The library and lobby bar

—
DA

Proposed

First floor level

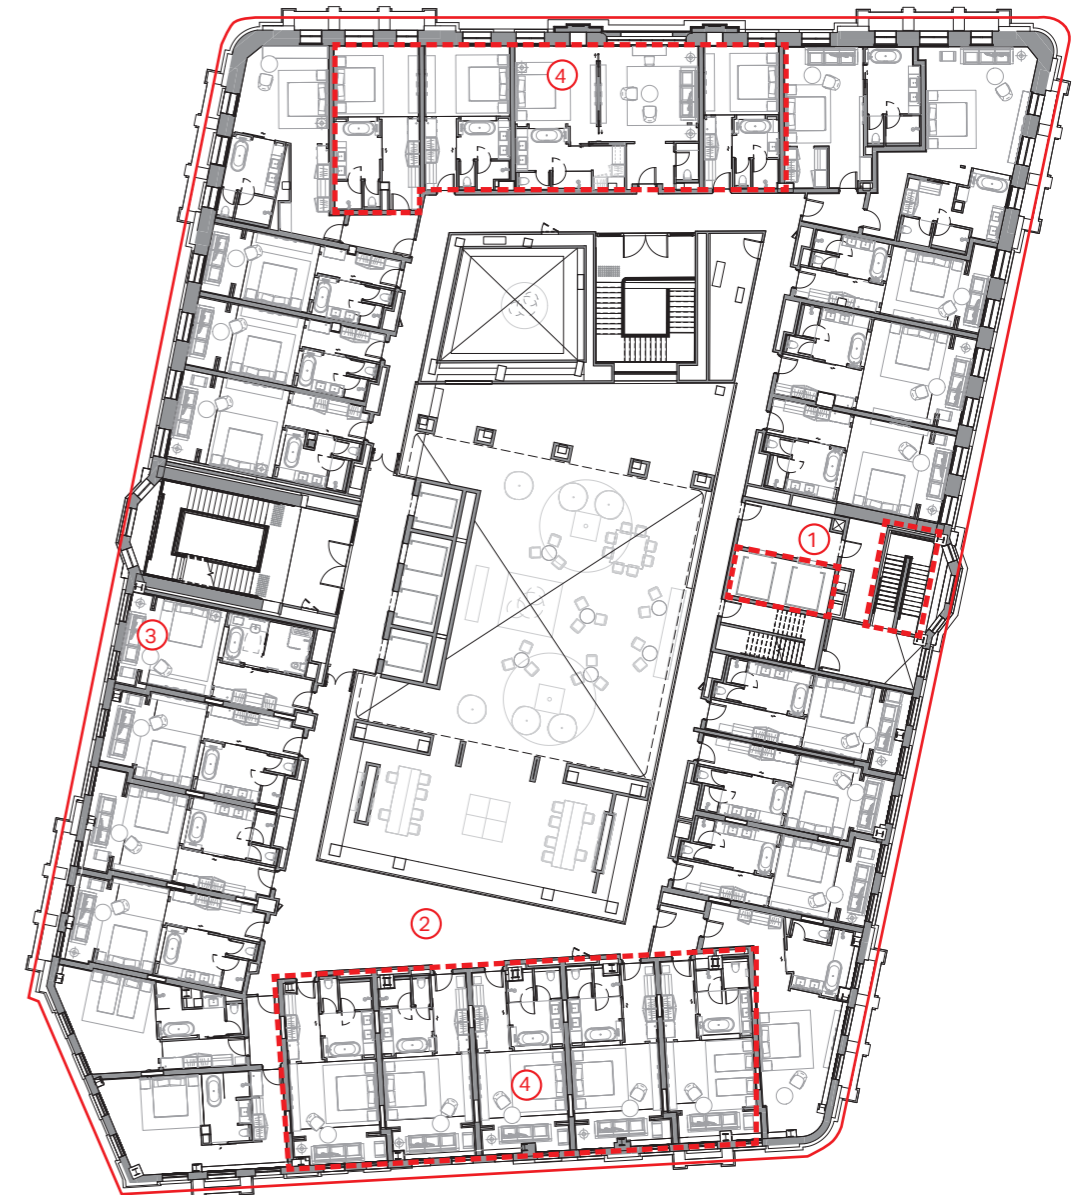
1. BoH lifts and stair moved north to create a more efficient core
2. Courtyard full height facade replaced with balustrade. External terrace removed.
3. Winter gardens removed and secondary glazing installed
4. Additional key

Second floor level

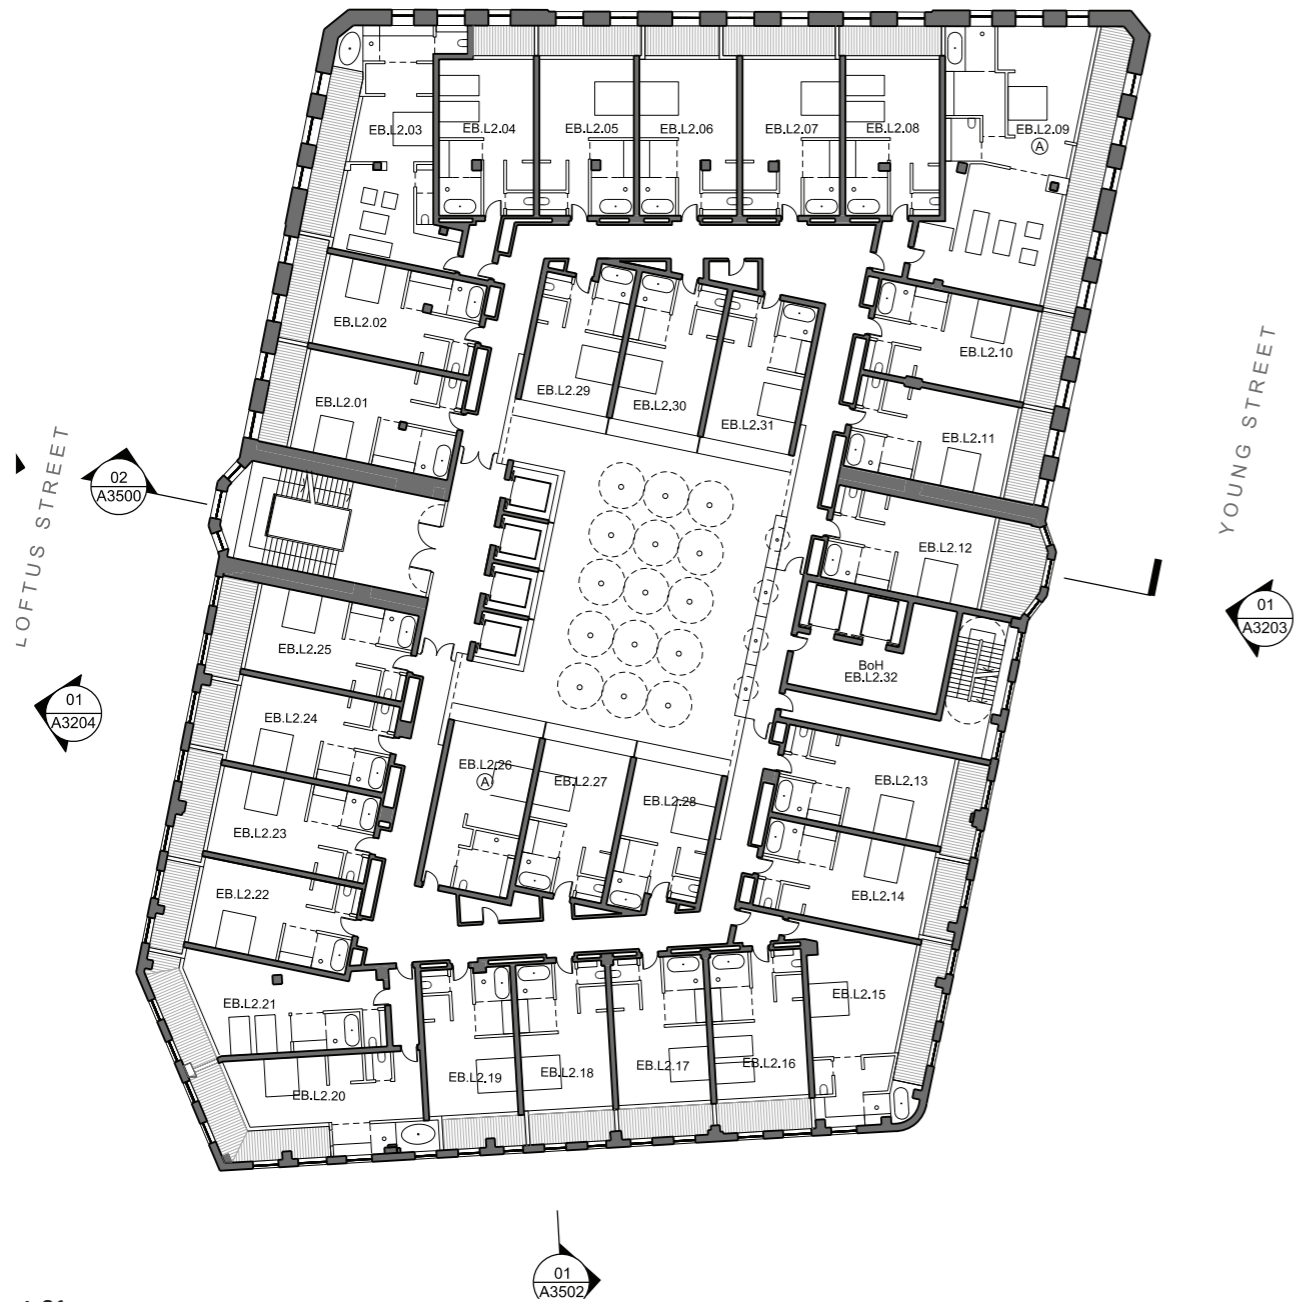
1. Courtyard glazed roof moved down to level 2 from level 6
2. BoH lifts and stair moved north to create a more efficient core
3. Winter gardens removed and secondary glazing installed
4. Additional key per zone

Third/fourth floor level

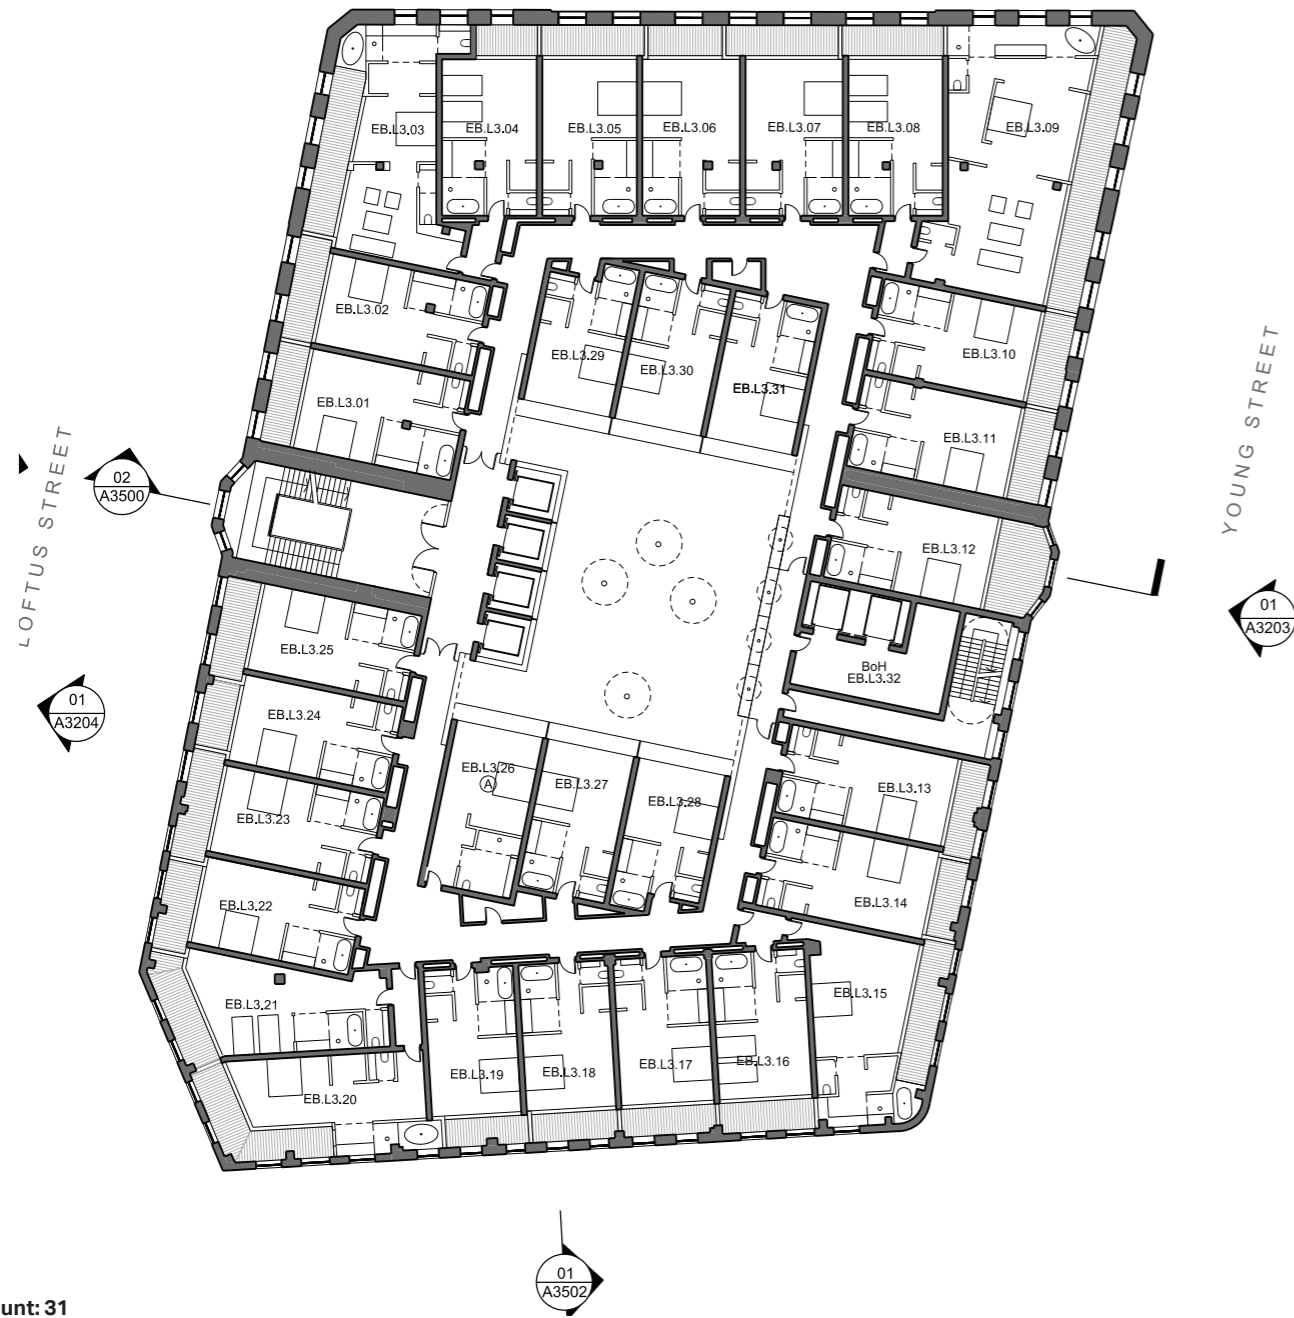
- 1. BoH lifts and stair moved north to create a more efficient core
- 2. Winter gardens removed and secondary glazing installed
- 3. Additional key per zone

Fifth floor level

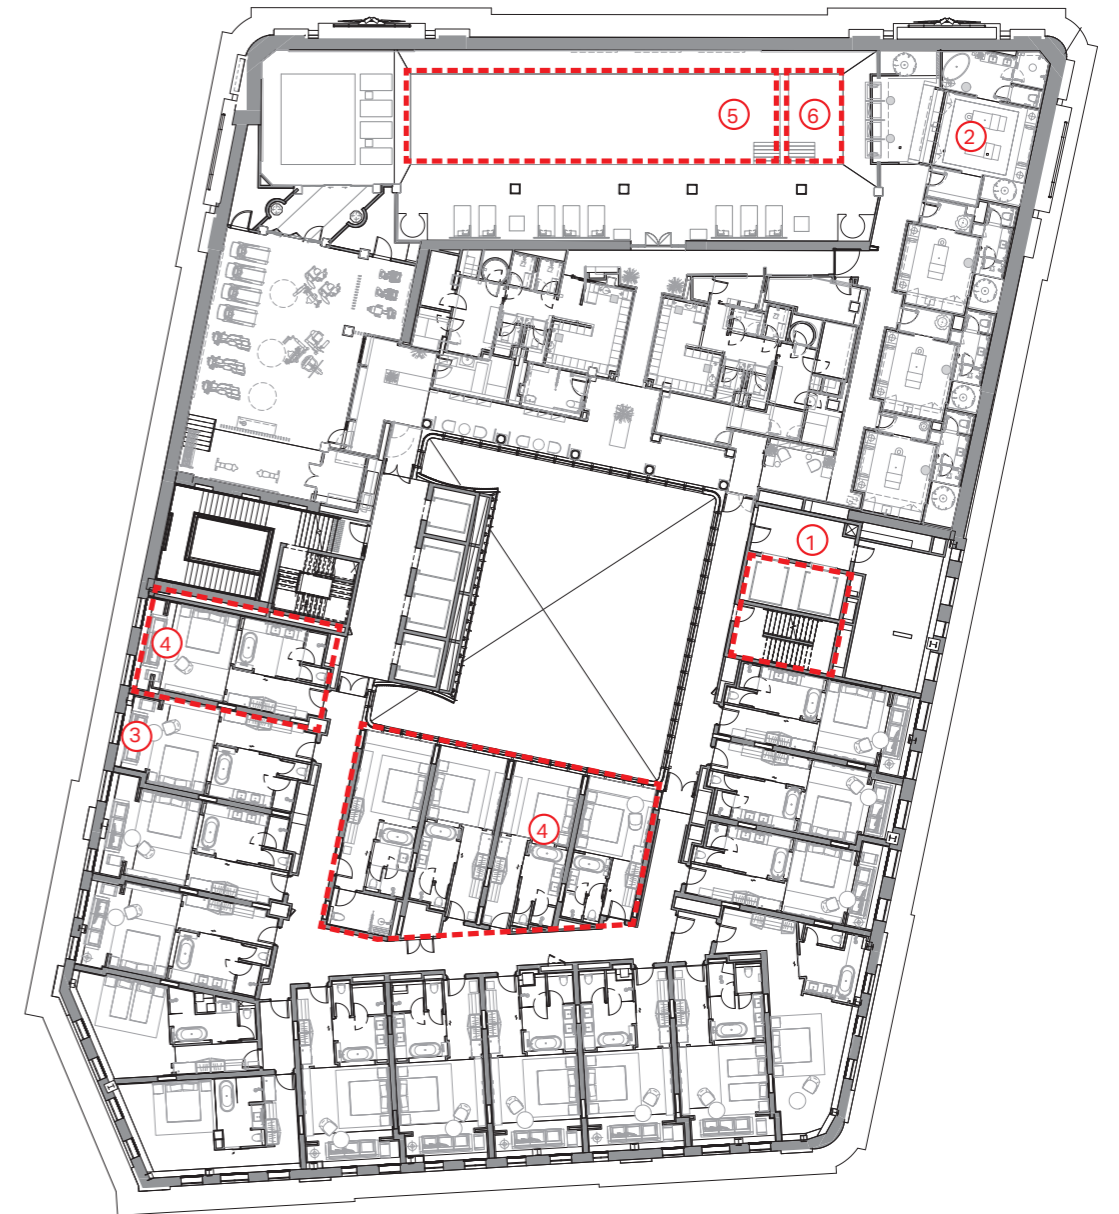
1. BoH lifts and stair moved north to create additional guestroom
2. Double spa treatment room moved north, yoga platform moved to west
3. Winter gardens removed and secondary glazing installed
4. Additional key per zone
5. Pool reduced in length and 'wet edge' removed
6. Vitality pool consolidated into one and moved adjacent to pool
